Gas Hob-Flush Burner Spillage

DESCRIPTION:

1. Remove the hob panel

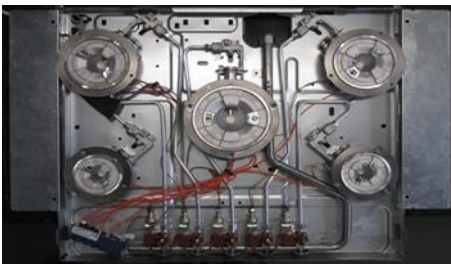
In case of accidental spillages over the hob surface, liquids may overflow under the appliance.

To add a graphite gasket between the burner body and the hob panel/plate as described below:
